Expansion of Lelystad Airport

How to optimize airspace design to accommodate air traffic bound for Lelystad Airport, a study.

*Hadriaan van Nes
KNVvL Study Group Airspace
Version 1.5
Woerden, July 24, 2017*

1. Present route proposals projected with all STAR's en SID's within Dutch airspace

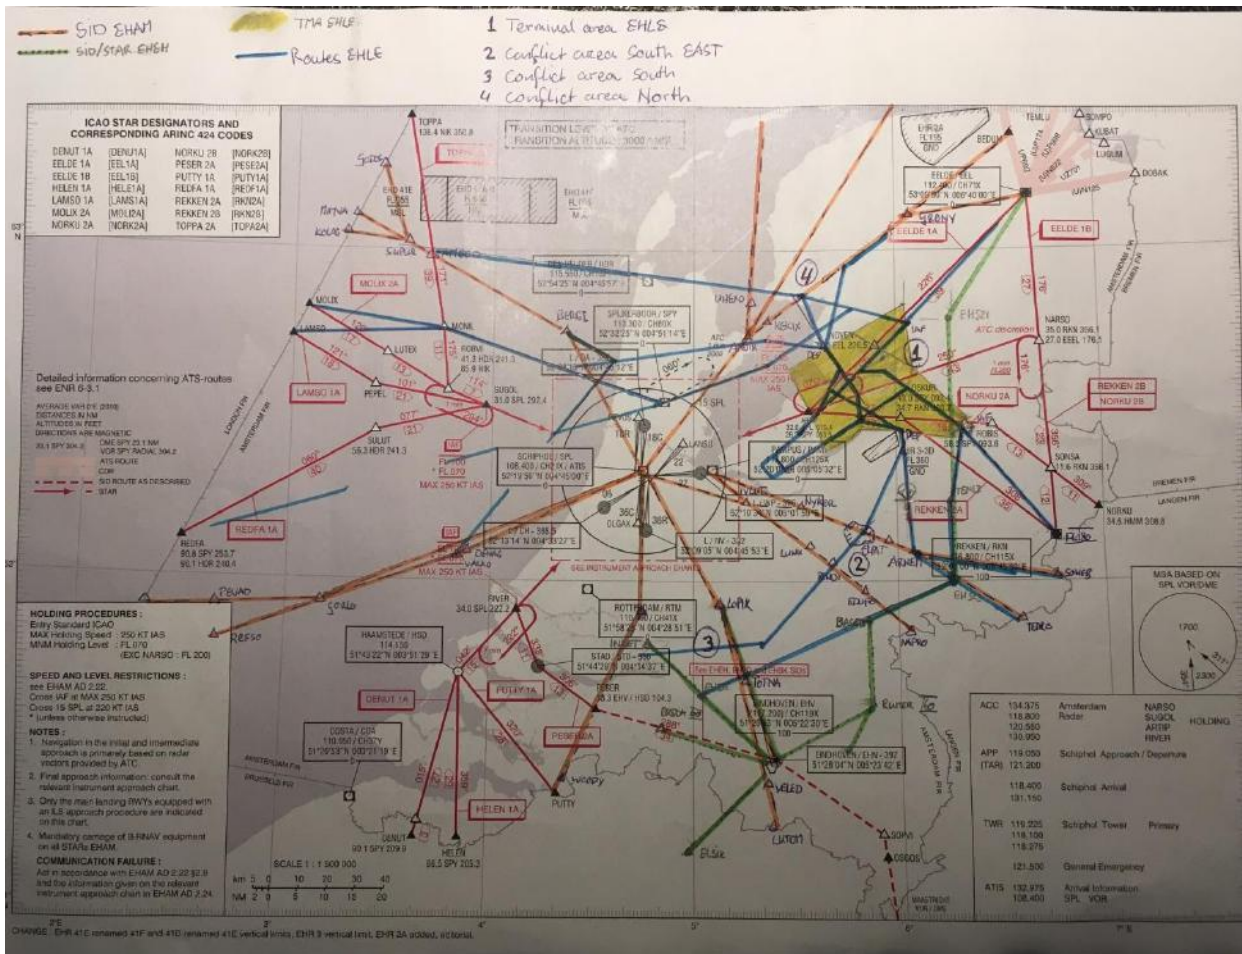
Most limiting departure routes outbound EHAM were studied, these are the departures from RWY 09 and RWY 18L, Eastbound and Southeast bound. A minimum crossing of FL150 is mentioned on the SID by the RNAV point of EDUPO, source AIP EHAM 2.22, 1.5.3. A minimum crossing of FL250 by the RNAV point of OLDOD is mentioned for the ARNEM, NYKER en ELPAT. The LOPIK departure prescribes a minimum crossing of FL100 by the point LOPIK and FL250 by the point .

The STAR inbound EHAM via ARTIP prescribes to cross ARTIP between FL70 and FL100. (Note: with strong westerly wind conditions ARTIP will be crossed around FL90 on an optimal CDA approach straight-in for RWY 27, including a deceleration segment). There are no MCA's defined for the RNAV points OSKUR and NOVEN. For crossing the border inbound the Netherlands a flying level is defined, in between FL280 maximum and FL180 minimum.

A minimum altitude of FL 70 at 18.8NM EEL and 22.2NM EEL are prescribed for EHGG and EHEH STAR's and SID's. Outbound EHEH a crossing altitude of FL60 at RNAV point RUMER is mentioned (departure and arrival). Outbound traffic EHEH with destination EHGG is allowed to fly at max FL95, and with destination EHAM at max FL75, according the AIP EHEH 2.22, 1.4.2.

7. Approach chart Schiphol, East Netherlands

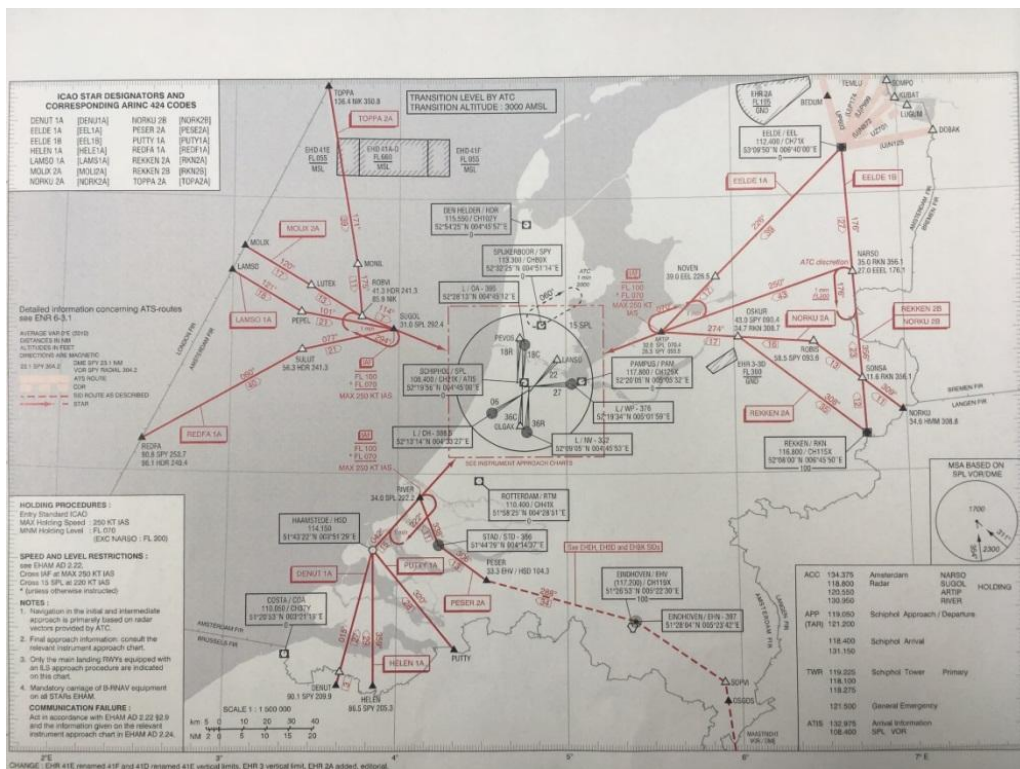
- Approaching air traffic seldom descends below FL150 before the RNAV points OSKUR or NOVEN (approach chart Schiphol, fig. 7);
- The projected CTR EHLE is laterally unnecessary large, especially when the planned SID and STAR routes are implemented, this results in less space for safe VFR routes;

- Vertically the projected TMA EHLE is too small to accommodate the intended amount of traffic;
- Only the Province of Flevoland and an area West of the city of Zwolle is studied to provide an environmental report; the areas East and North of Zwolle were not studied and are not part of the environment report (MER);

- The impact of the proposed TMA EHLE is unclear taking into account the gliding activities of the ACS and ZCNOP;
- The agenda and procedure according the document "Work process simultaneous use of airspace and procedures" was not followed; a level playing field was biased this way;

- Create CTR and TMA areas using the “upside down wedding cake” method as mentioned in the vision Dutch airspace 2012, and used worldwide to optimize use of airspace;

- Put the CTR North boundary along the line Highway A6 towards the village of Swifterbant;
- Put the CTR South boundary along the road N305, West of the village of Zeewolde;

- Make use of the unused airspace within CTA Amsterdam North, East and South of the RNAV points OSKUR and NOVEN to accommodate a TMA EHLE. We recommend a MCA of FL120 at OSKUR and NOVEN for traffic inbound Schiphol;

- Increase the lower altitude of the ARTIP holding pattern by 1000 feet till FL80, this will have no effect on the Schiphol air traffic;
- Create a multi-stage TMA with a lower level of FL65 till the RNAV points OSKUR and NOVEN, West of these RNAV points the lower level will go down till 2500 feet in a multi-stage way; (fig. 8)

- The upper level of TMA EHLE will be at FL115 till the RNAV points NOVEN and OSKUR, West of these points the upper level will descent to FL75 in a multi-stage way;

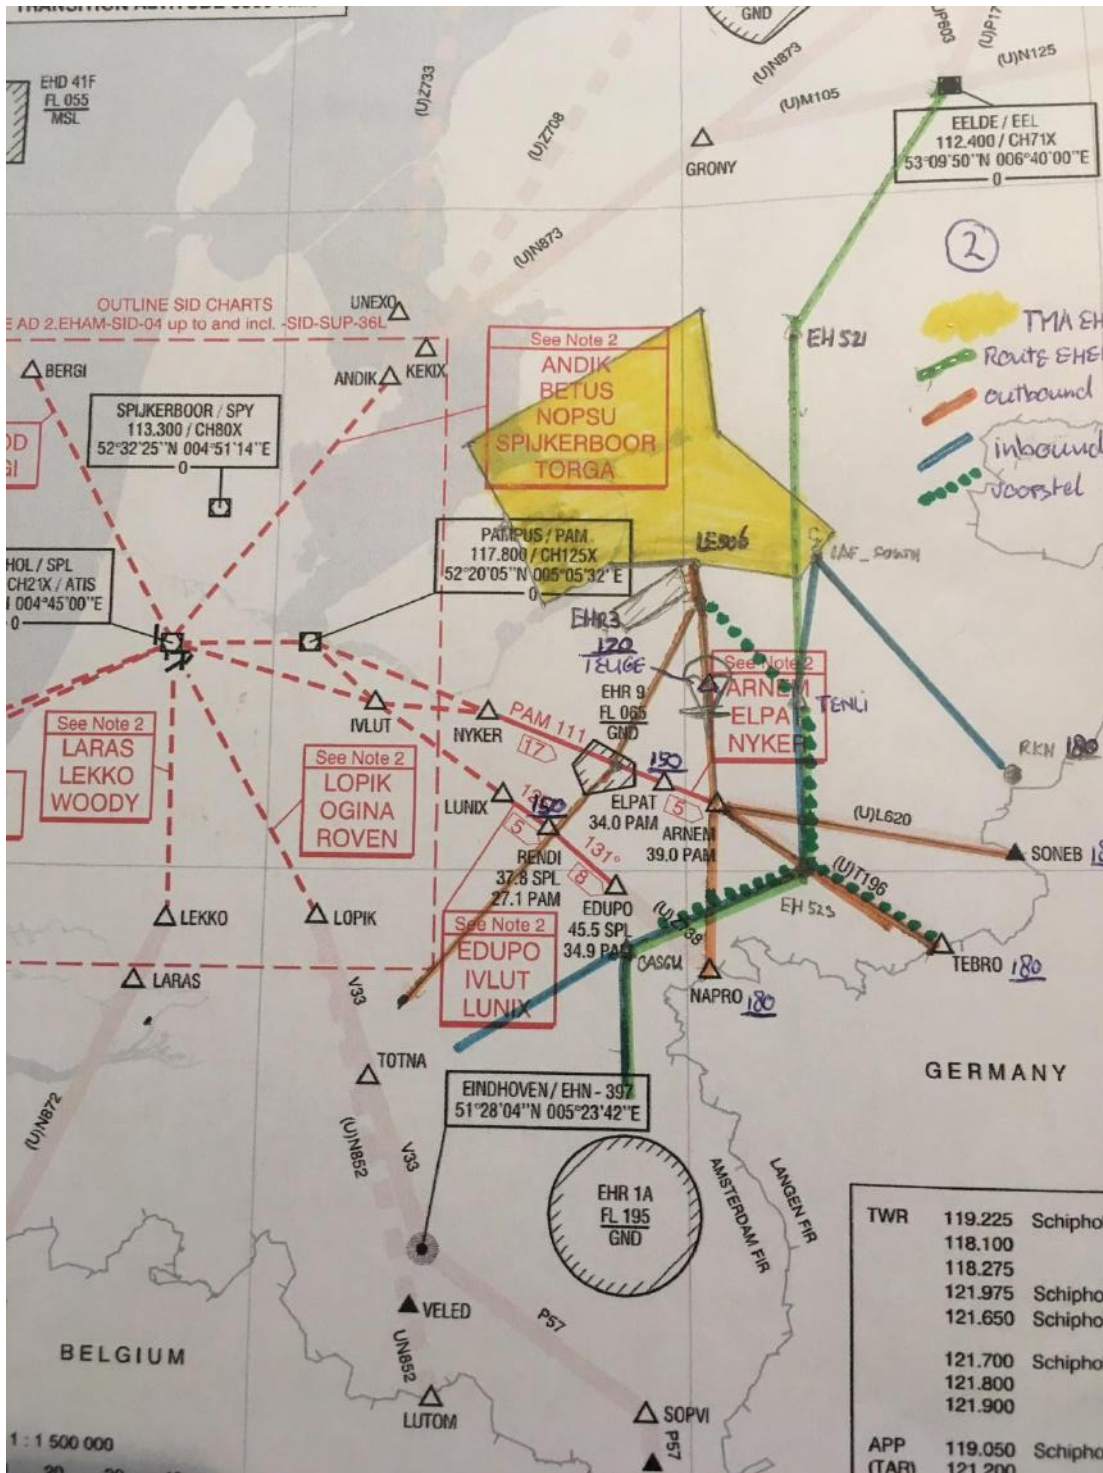
- The proposed routes result in unnecessary low flying for a long period by airliners underneath CTA Amsterdam;
- Air traffic bound for EHLE is the only air traffic which is not allowed to use CTA Amsterdam;

- Air traffic inbound Schiphol is no conflict with outbound EHLE traffic in the direction Southeast;
- Schiphol outbound traffic needs to cross the border with Germany at a sufficient high level so creating plenty of airspace in the area of Deventer-Apeldoorn-Arnhem. Without operational restrictions you can define airspace for arriving and departing EHLE traffic;

- Outbound route "OUT-02" is unnecessarily projected at a low level overhead the airfield of Teuge;
- The proposed maximum flying altitude overhead the RNAV point ARNEM on route "OUT-2" makes it almost impossible for airliners to cross the German border at the MCA of FL180;

- The length of the arrival route IN-02 towards IAF_SOUTH is too short for an approach with normal flying techniques; (Note: Regarding the MCA of FL180 at RKN the profile is perfect for a CDA, including deceleration segments, onto the final approach at EHLE, the approximate crossing altitude at IAF_SOUTH will be FL090

- There is a conflict in the arrival route IN-06 with the departure route OUT-2 and the routes via ARNEM-SONEB plus ARNEM-TEBRO, in altitude, route and airspace.

- Assign MCA's for the RNAV points RENDI and ELPAT or ARNEM. We suggest a MCA of FL150 at these points; (note: This altitude is easily manageable with a B777-300 at MTOW with reduced climb thrust departing from RWY 09 at EHAM with standard flying techniques.)

- Change route OUT-2 towards OUT-7 till RNAV fix RAKIX before turning onto the departure route via the airway to ARNEM;
- Change Route OUT-2; from the departure fix LE506 towards the RNAV point TENLI to pick-up the airway between EHGG and EHEH, including connection onto airway (U)T196 to TEBRO;

- Create a RNAV fix TEUGE, preferably at the North line of the present jumping area and define a MCA of FL120. Another option is to make this route a conditional route/airway, only available when there is no parachute jumping taking place;

15. routes proposal area 3

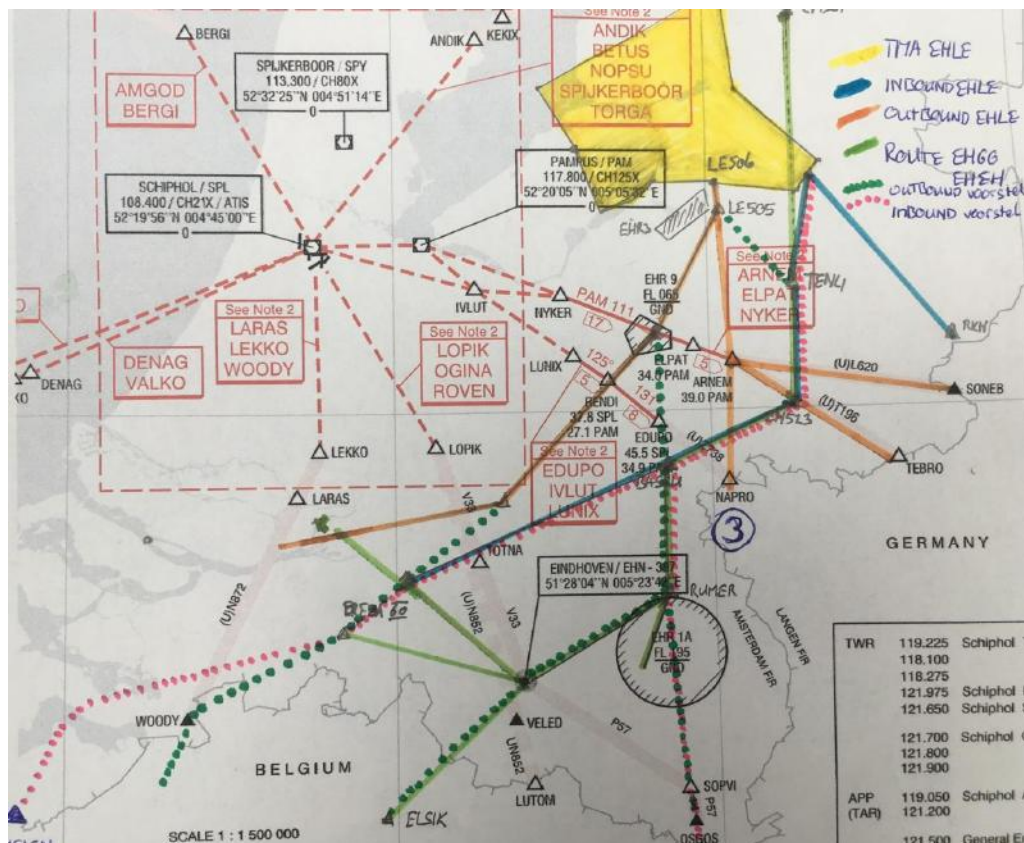
- Air traffic will have to fly along routes OUT-7, OUT-2 and IN-6 through Nieuw Millingen TMA D with a lower level of FL65 and higher level of FL195
- Within TMA Nieuw Millingen a TRA-12 and TRA-12A are situated, military exercise areas.
- All airways but one (UN852 via LOPIK to LNO) are one-way airways.
- There are not many options on connecting routes inbound the Netherlands arriving from the South.
- It is not clear at what level Brussels control accepts Dutch outbound air traffic.
- Route IN-06 is connected to a Southbound only airway UN872 via WOODY.

- Connect route OUT-7 at an higher altitude onto the existing WOODY departure outbound EHEH (and EHAM)
- Create an outbound route via OSGOS onto the OLNO departure outbound EHEH, via RNAV points RUMER and SOPVI.
- Design route OUT-7 via overhead EHEH to join the ELSIK departure outbound EHEH.
- Connect inbound route IN-06 onto inbound boundary point HELEN.
- Create an inbound route via the South via the OLNO arrival to EHEH to connect via RNAV points OSGOS, RUMER and BASGU onto the regular route.
- This creates the following advantages:
 - o More options, less peak traffic
 - o More and better options to connect onto the airways in an early stage.
 - o Less interference with the MME.
 - o More options to accommodate an optimized flightpath without interference of the existing air traffic.

16. Routes north above the Netherlands, area 4

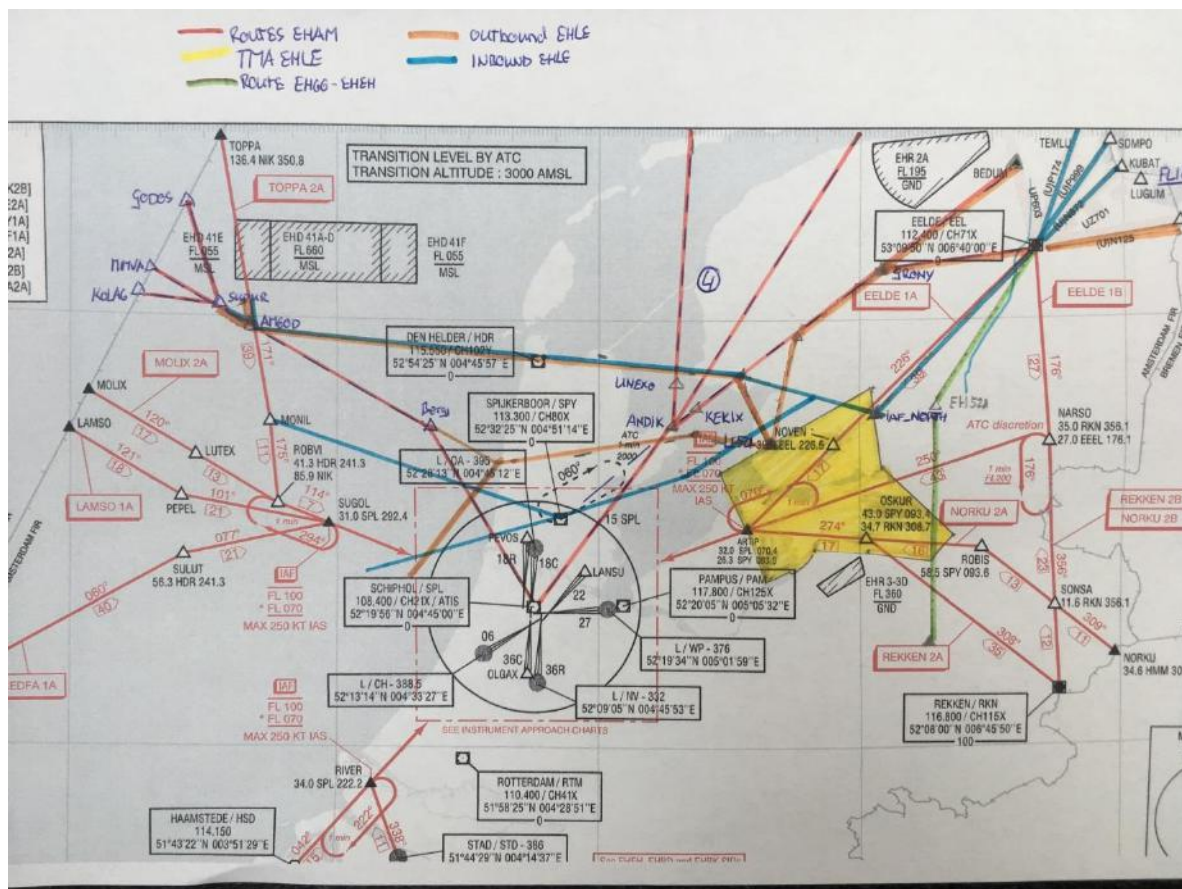
- The route proposal is crossing all kind of traffic above the Province of North-Holland.
- The routes IN-11 and OUT-12 are projected the same and at the same altitude, it is unclear if this is a maximum altitude;
- Routes IN-13 (A&B) are constructed at a realistic altitude along Schiphol through the Schiphol TMA;
- There is a very sharp turn projected in the route IN-11 and IN-13 at IAF_NORTH;
- Approaching and departing traffic to the North via the points EEL and GRONY are via existing routes without interference with other traffic (due to geographic distance between the two airfields);
- No altitudes are defined for route OUT-10 via ANDIK and DENAG;
- It's unclear when air traffic can resume their climb above FL60 on route OUT-1;

- Develop an ARC procedure on the IN-11 and IN-13 with enough altitude to accommodate a CDA onto IAF_NORTH;
- Define a MCA on the departure routes of Schiphol via SPY and ANDIK. The SGA recommends a MCA of FL100 at the RNAV points UNEXO and KEKIX;
- Define a MCA at GRONY of FL180
- In doing so:
 - o Creating space to accommodate optimized flight profiles
 - o Creating an ARC onto IAF_NORTH makes the route and profile more predictable for airliners and air traffic controllers
 - o It is possible to facilitate the minimum flying altitudes on routes OUT-10 and OUT-12 at an higher altitude, in doing so there will be less interference with Schiphol traffic;
 - o It is possible to climb on route OUT-01 with the optimum flight profile.

Bijlage 2: Ligging route B+ en B++, stiltegebieden en gehinderden in Gelderland en Overijssel

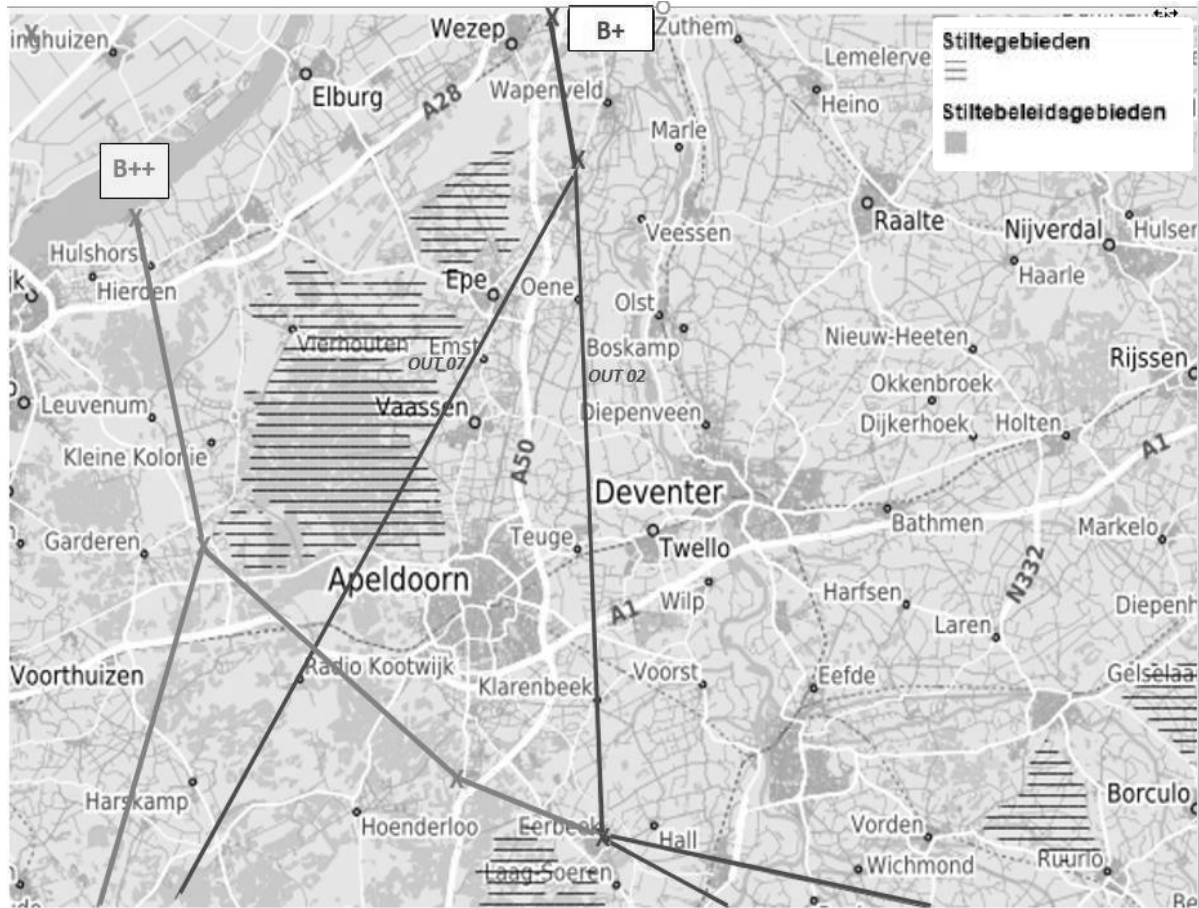
- Echter, de geoptimaliseerde variant B++ route:
 - is ruim 20 kilometer korter;
 - vliegtuigen vliegen daardoor korter op relatief lage hoogte;
 - leidt tot een substantieel lager aantal gehinderden op de grond³ binnen het MER-gebied;
 - loopt in Gelderland en Overijssel over veel minder over dorpen en woonkernen met als resultaat circa 90% minder geluidsoverlast⁴;
 - leidt, vanwege de kortere vliegafstand tot een besparing⁵ van ca. 2,5 miljoen liter brandstof per jaar en minder CO₂-uitstoot;
 - blijft vrij van de aangewezen stiltegebieden op de Veluwe;
 - blijft vrij van het gebied boven en rondom luchthaven Teuge en neemt de bedreigingen voor het voortbestaan van het Paracentrum en de Luchthaven Teuge weg.

Luchthaven Teuge en het Nationaal Paracentrum verzoeken aan de staatsecretaris om de voorgestelde alternatieve route B++ te onderzoeken en mee te nemen in vastlegging van de vliegprocedures voor Lelystad.
